6612C-07A

S E R V I C E N O T E

Agilent 6612C DC Power Supply

On faster computers, when programming over GPIB, a random error will occur.

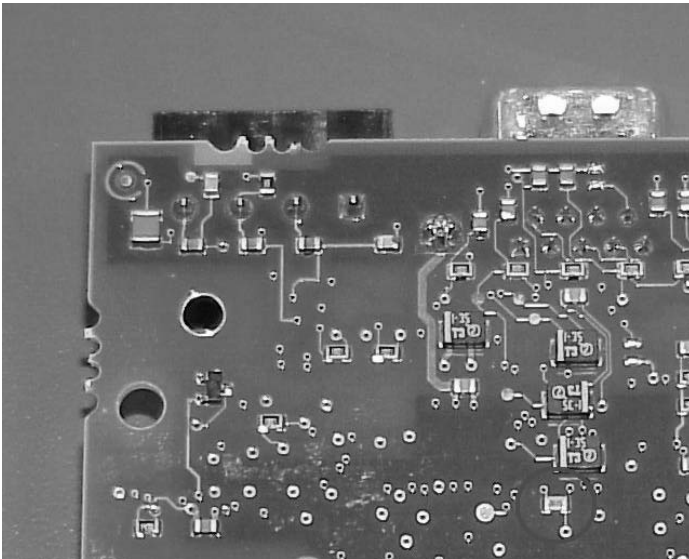
When programming a unit over GPIB, a random error -113 (“Undefined header”) will appear on the unit. This error can be read back via the front panel or over the GPIB bus.

Change resistor R1246 (see picture for location) from 511 Ohms to 100 Ohms (part number 0699-3058). This requires un-soldering and soldering a surface mount component and can be very difficult. This does not require re-calibration.
